STAFF REPORT: 2/9/2022 MEETING

APPLICATION NUMBER: #22-7664

ADDRESS: 2485 BURNS

SCOPE: ALTER FRONT PORCH; ALTERATIONS AT REAR PORCH AND SECOND FLOOR SLEEPING PORCH COMPLETED WITHOUT APPROVAL

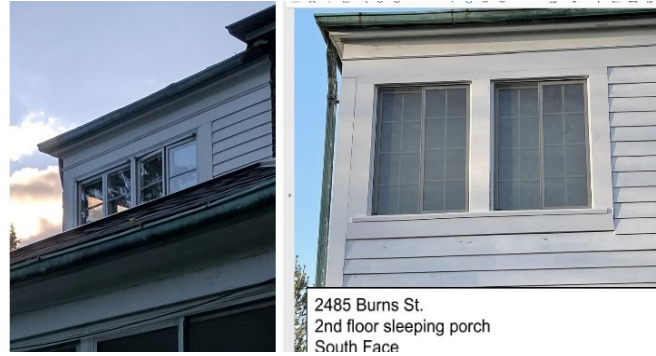
- Expand Porch:
 - Demolish, excavate and haul away existing front porch
 - Compact infill
 - Install pavers (Old World Vintage Series “Holland-Antique Blend” 4in by 8in units cement pavers) with sand infill at two levels:
 - First level in a semi-circle, 27ft, 5in wide
 - Second level (supports balcony columns) in semi-circle, 10ft 11in wide
 - Install limestone step perimeter with crushed limestone infill
- Install Wingwalls:
 - At each end of new first level porch, install two (2) partial wing walls (8ft long, 2.3ft high, 6in wide) terminating the semi-circle that consist of railing, newel post and balusters, with a planter bowl/vessel (1ft tall) on top of the leading newel post.

- It is staff's opinion that the introduction of 4x8 cement pavers, replacement of the square form with circular forms, and the introduction of wingwalls destroys the character defining features of the front elevation critical to an understanding of the building's style by obscuring the front elevation windows and introducing a new style and historically anachronistic material, scale and design that is not appropriate.

- It is staff's opinion that the proposal to change the front porch's material from cast stone and limestone to cement block that does not match the house's material nor scale, changing the shape of the front porch to a circular form and introducing "wing walls" that obscure's the front elevation the house's Georgian Revival architecture would destroy the original *scale, design, and materiality* of this historic property, and therefore does not meet the Secretary of the Interior's Standards for Rehabilitation.

- Staff does offer the observation that retaining the original material of the porch, its rectangular form and scale of the top step supporting the columns, and the potential expansion of the porch floor minus the balustrade ("wingwall") could be an appropriate solution that would meet the Standards.

- The top surface of the front porch floor remain the same in dimension, material and size to support the existing columns.
- The proposed lower step of the front porch consist of the same surface material as the original top step or brick that matches in material and scale of the house with a limestone perimeter step.
- The proposed lower step retain the rectangular form as the original step and reach no wider that the outer limits of the first set of windows on either side of the door.
- The applicant provide HDC staff a revised plan of this front porch for review and approval.

Drawing 1, by Applicant: (Southeast) side elevation excerpt from 2017 COA showing approved new knee wall and original columns.

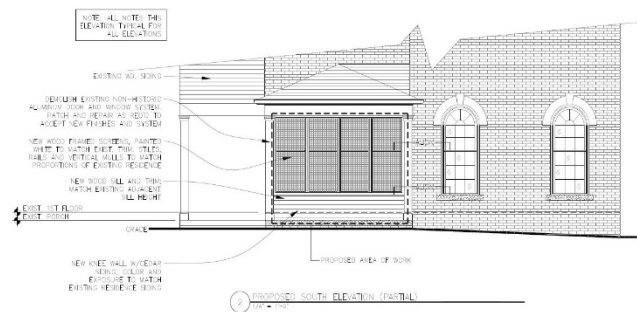
- Removed all aluminum sliding doors and tracks.
- Maintained fascia board below gutter and paint white.
- All screened-in knee walls replaced with full walls and windows:
 - Northeast Face: 6'1" length with 1 window @ 36", centered
 - Southeast Face: 11'6" length with 2 windows @ 41" each, centered
 - Southwest Face: 13'2" length with 2 windows @ 27" each and 1 door @ 34", evenly divided
- Installed Marvin Signature wood windows
- Installed Thermatru fiberglass door and Provia steel storm door
- Installed 7" Hardie board to match sleeping room siding.
- Add two exterior electrical outlets, fed from box existing outlets in screen porch
- Paint siding white to match all other wood on house exterior
- The floor plan dimensions remain the same as the original porch.

- Staff has the opinion that the open-air quality of the rear, first story screen-in porch, which was approved to introduce a modest knee wall and approved by the HDC in 2017 is a distinctive, character-defining structure. This porch, publicly viewed from the front, had a quality of light transparency with matching character-defining columns that was destroyed by the construction of the solid block massing. This impervious form hides the rear French doors and arched windows (see photos 2-4 & 7) and reads like an addition rather than a porch. Staff also observed that the corner columns of the screen-in porch have been removed on the southwest wall panel and not retained as described in this application. The addition of vinyl transoms over the 2x3 double hung wood windows introduces a new material and pattern that does not complement the existing 3x3 configuration of existing windows of the house.

- It is staff's opinion that the full replacement of the rear screened in porch, which is publicly in view from the front yard with a design that did not conform to the HDC's COA, changes the character from an open air porch to a enclosed room with window and transom configurations that do not match the house has destroyed the original *scale, design, and materiality* of this historic property, and therefore does not meet the Secretary of the Interior's Standards for Rehabilitation.

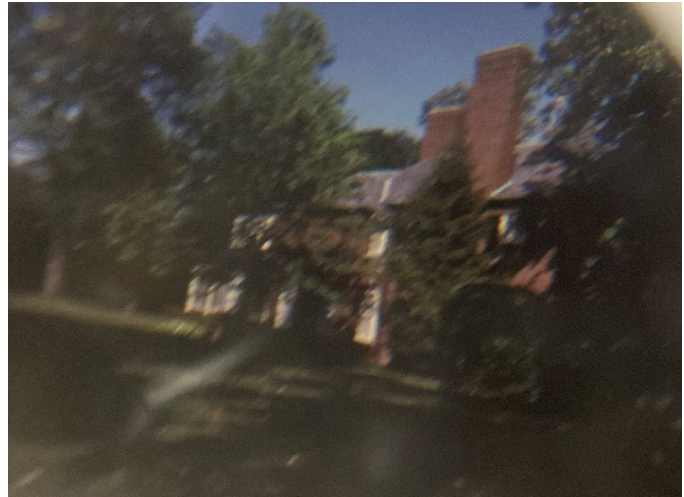
- Indian Village Historic District was established in 1971.
- Staff observed that the Sanborn map of this property shows that both the rear porch and the rear sleeping room are not shown as part of the original structures to the house. Staff found a hard copy of the designation slide for this property on file, showing the rear porch. Also, due to the method of the construction, Staff has the opinion that the rear sleeping porch was likely present at the time of historic designation. The owner stated that they did not know the construction of these additions as they predate their previous owner, but they offered the opinion that they were likely constructed in the 1960s or 1970s, as stated by their window restoration consultant.

- Staff confirmed with the owner that the original metal casements of the sleeping porch are in storage.
- Staff has the opinion that the rear sleeping porch's wood clap board siding with the mitered corners and the operation of the casement windows with true-divided light were distinctive, character-defining features. The mitered edge of the clapboard has been replaced with trim board, the casement windows with vinyl sliders with between-the-glass grids that do not match the configuration, design, material or operation of the original windows. Although this location is not within prime public view, it is staff's opinion that the loss of the casement windows reduces the open-air quality of the sleeping porch and replacement of the mitered edge clapboard with board trim reduces the craftsmanship of the siding. Vinyl windows of this type and quality are inappropriate.
